Vic Park Tunnel Project - Section 92 Response Report 3

Prepared for
Auckland Regional Council

By
Beca Infrastructure Ltd

July 2006

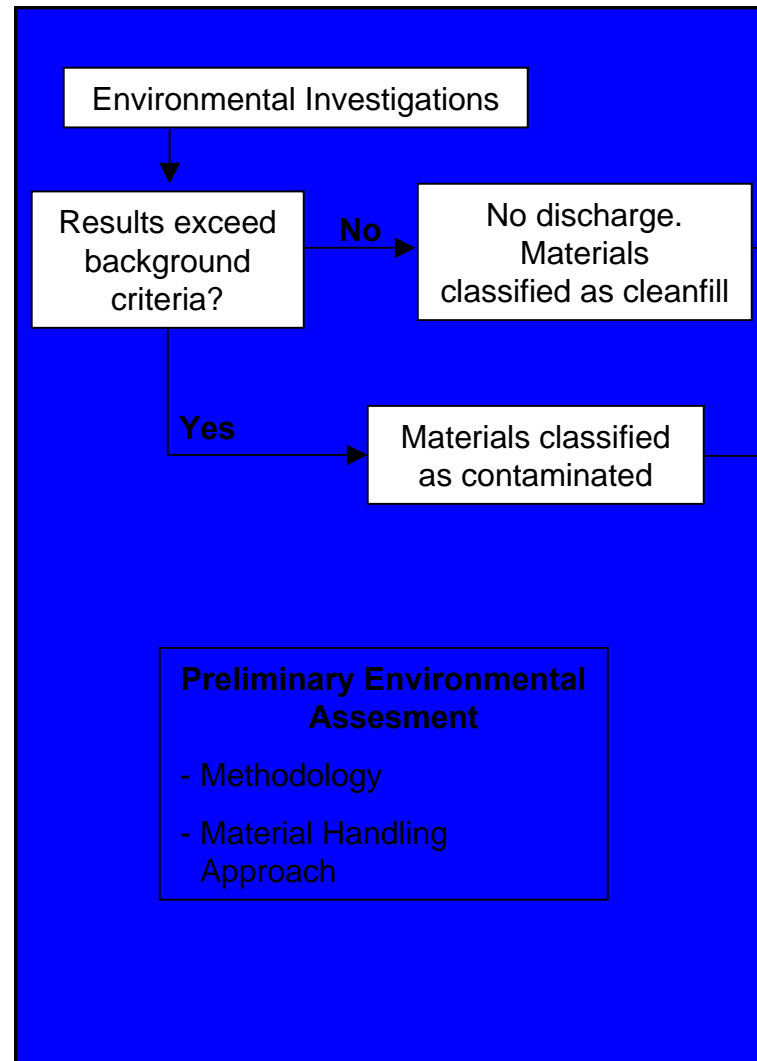
16.4 Long Term Diversion of Groundwater (Question d)).

Figure 13 of the Hydrogeological and Engineering Issues Report (refer to Appendix B of the AEE) presents modelling results of long-term groundwater flowpaths for one tunnel section and indicates flow splitting at about 5.5m depth in the Waitemata Group upstream and recombining at about 6m depth in the Waitemata Group downstream. The latter therefore provides for potential contaminant introduction to new 'clean fill' above the tunnel roof and also downstream to a depth of about 6m.

Contaminant migration to 'deeper' levels would therefore be restricted to a depth of approximately 6m based on modelling. As noted within previous documentation (eg Assessment of Contamination), it is unlikely that the contaminants found in the shallower groundwater environment will be mobile enough to migrate downwards against the natural groundwater circulation. Whilst the current effect is assessed as being 'minor', the current design incorporates by-pass drainage systems to reduce the likelihood of cross contamination and / or diversion of contaminated groundwater.

- Appendix 2:
**Overview of
Contaminated Materials
Investigation and
Handling**

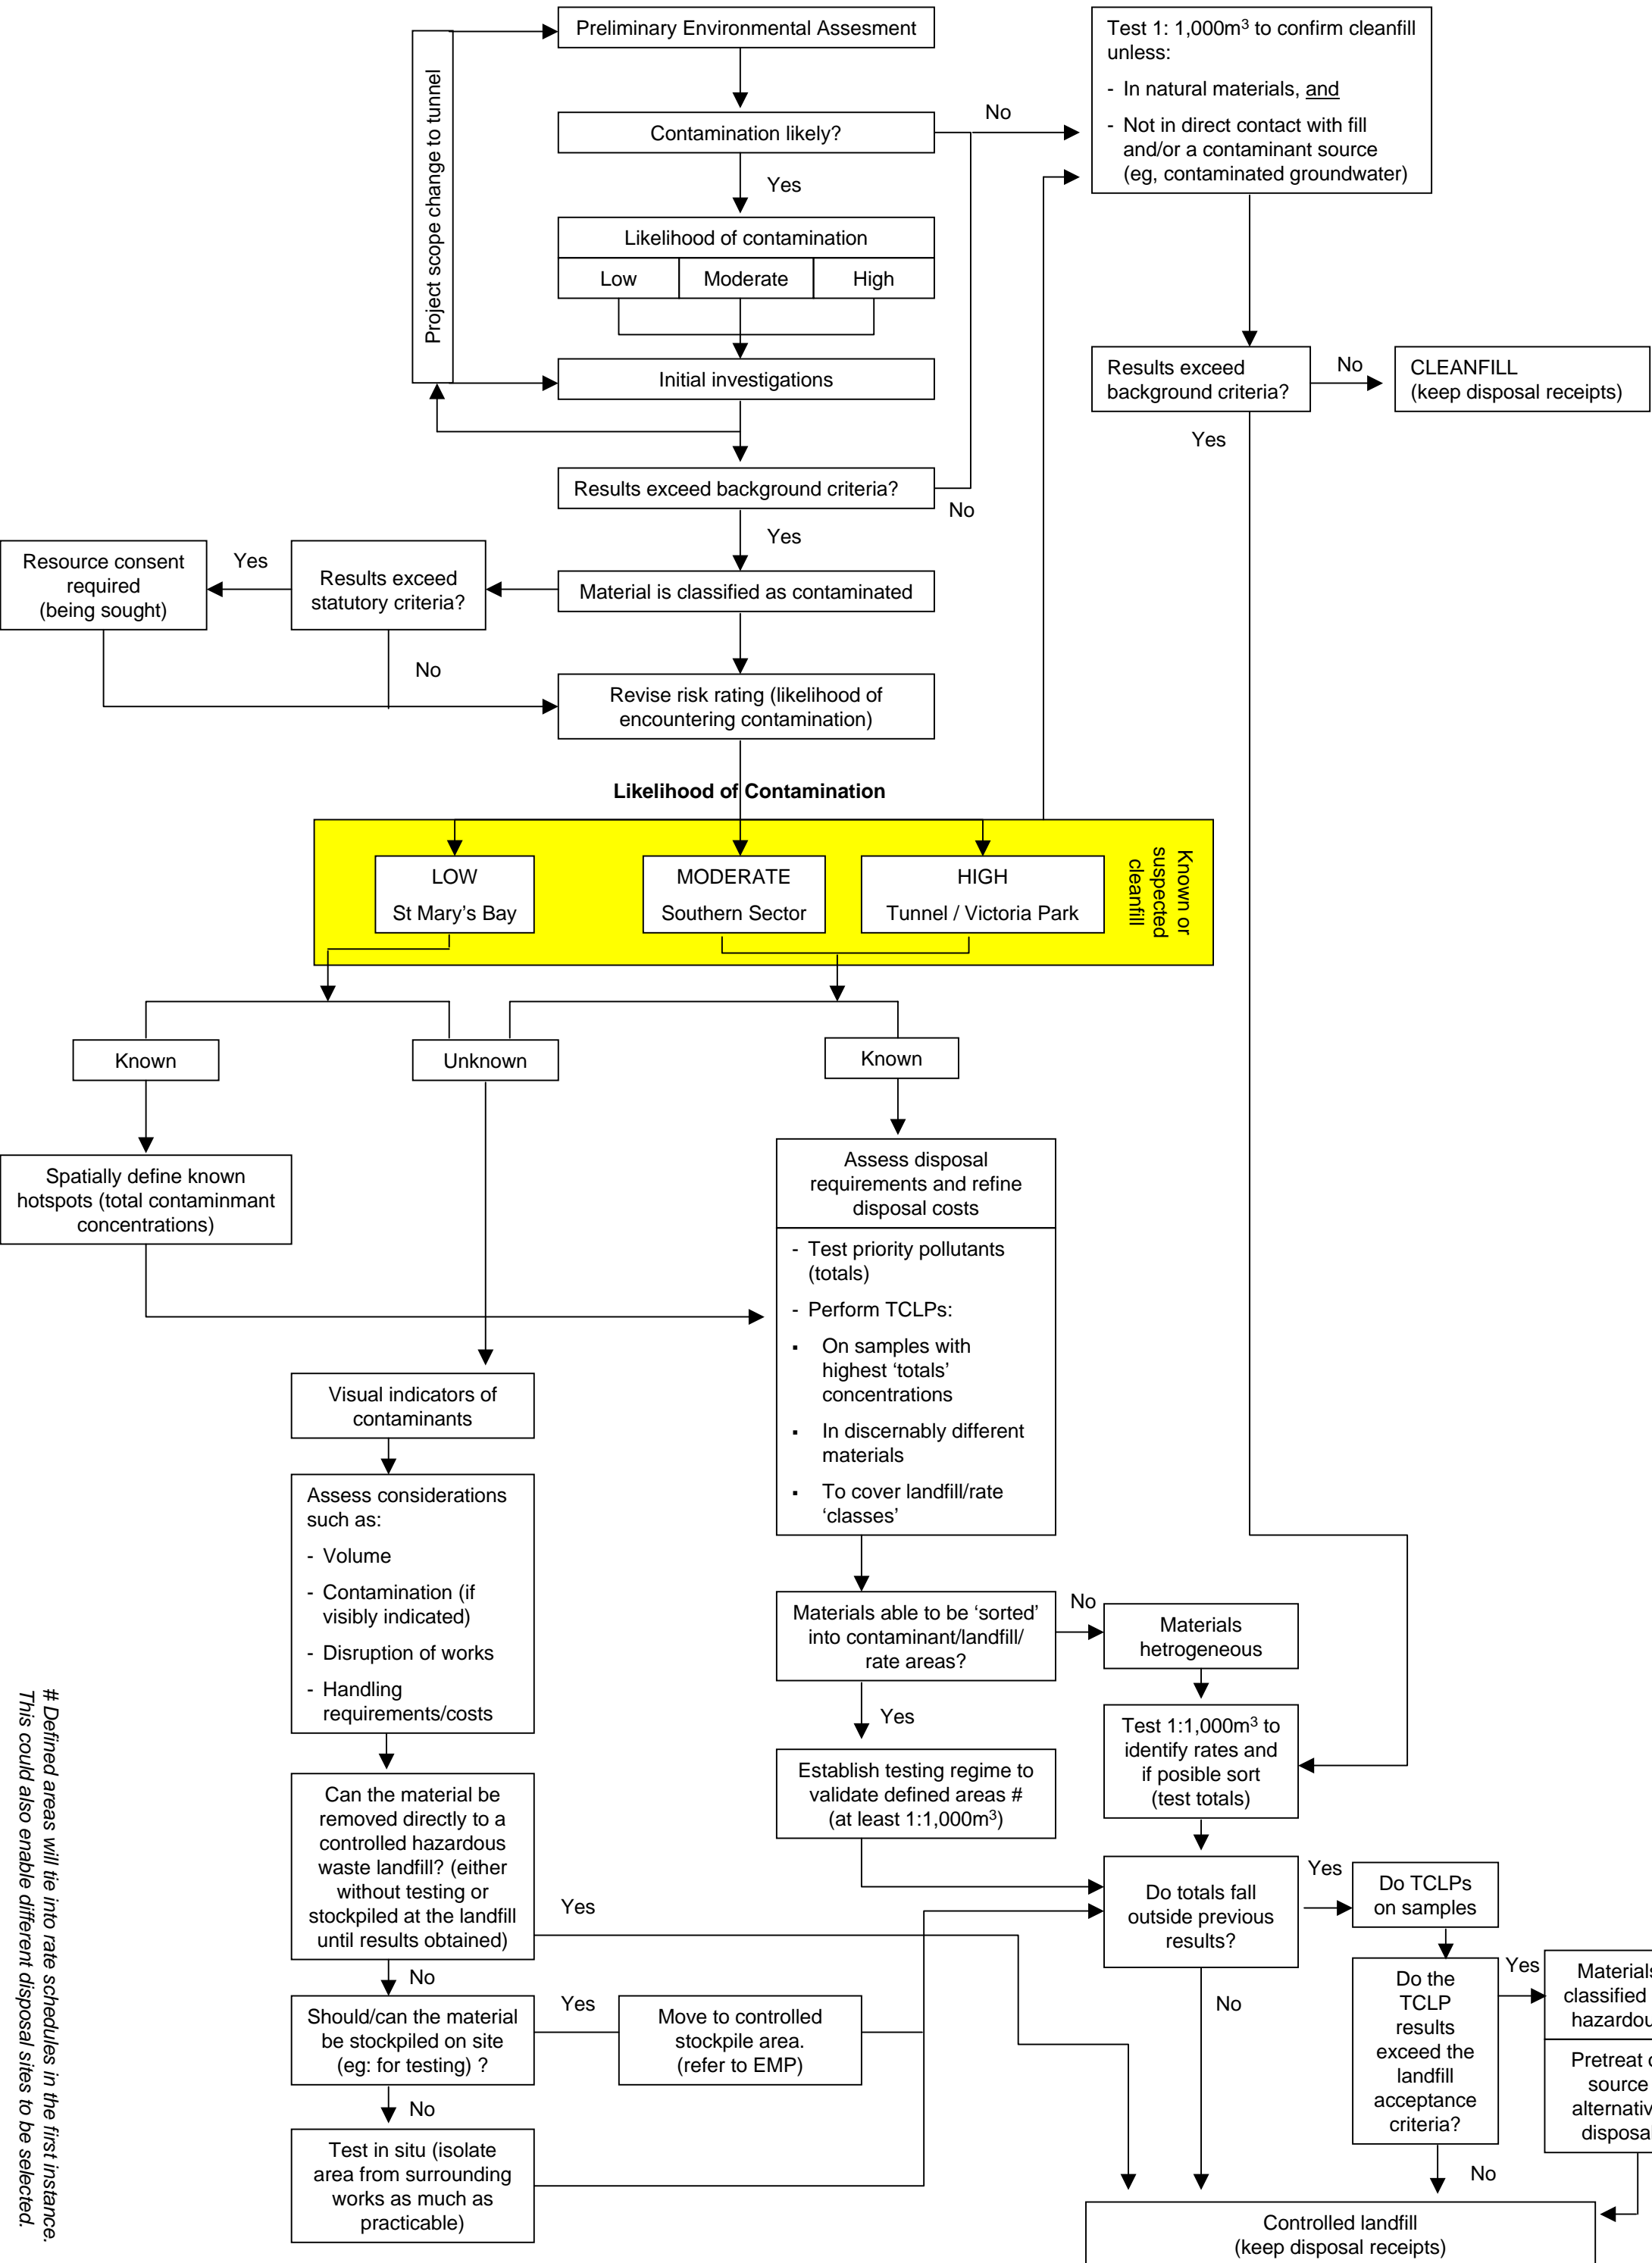
It may be appropriate to have a separate detailed contamination plan that would deal specifically with the contamination issues and contamination monitoring. Please comment.

An overview of the proposed environmental management framework is provided within the EMP (refer to Figure 1 of the EMP; Appendix H of the AEE). Further detail on how contaminated materials handling specifically fits into that structure is provided within Appendix 1 of this response. Additional detail is provided in Appendix 2 to this response, by way of an overview flow diagram of the investigation and testing regime for the project.

Please refer to previous discussions in sections 1.1, 1.6, and 4.4. We do not consider the existing level of information to be insufficient for consenting purposes. However we note that as part of the processes moving forward, additional testing will be undertaken. This has been overviewed within the flow diagram attached as Appendix 2 to this response.
